SERVICE BULLETIN SPSB009

SUBJECT: SUPPLIER/VENDOR RECALL OF PS70104 HOUSINGS (METAL FLEX HOISING INC)

STATUS: MANDATORY INSPECTION AND REPLACEMENT OF RECALLED HOUSINGS

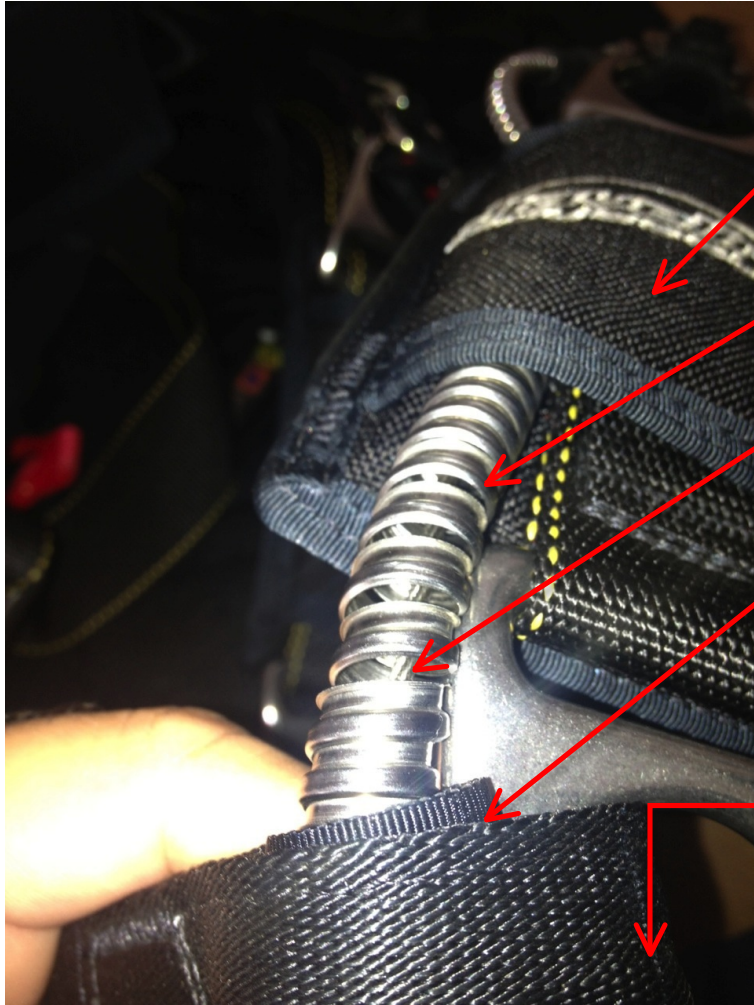
Who can inspect: Anyone can inspect this area. See photos below.

WEARERS LEFT SIDE:

RING COVER

RESERVE RIPCORD HOUSING (LOWER END)

SEPERATED HOUSING (FOR REFERENCE)

CHEST STRAP BUFFER

CHEST STRAP

What to inspect: All JA101-XX harness container systems listed in table above. Inspect Reserve Ripcord housing.

If the serial number is listed in the above table, inspect the available exposed reserve ripcord housing. Locate the lower end of the housing, which is clamped to the Main Lift Web, just above the reserve ripcord pocket. Inspect the exposed length of housing from the clamp upwards; ensure that the coil has not separated/unraveled. Be sure to inspect the section that is routed through the chest strap.

A. HOUSING FOUND TO BE INTACT (GOOD): The rig may continue to be jumped with periodic monitoring until the next repack cycle or earlier elective replacement. However this housing must be replaced at the next repack cycle. See <http://www.sunpath.com/support/HousingReplacement.pdf> for instructions for your rigger to complete the replacement of the housing.

B. HOUSING FOUND TO BE SEPERATED/UNRAVELLED (BAD): The housing must be replaced before the next jump by a certificated senior or master parachute rigger (or foreign equal) or the manufacturer. See <http://www.sunpath.com/support/HousingReplacement.pdf> for instructions for your rigger to complete the replacement of the housing or instructions to send your system back to the manufacturer.
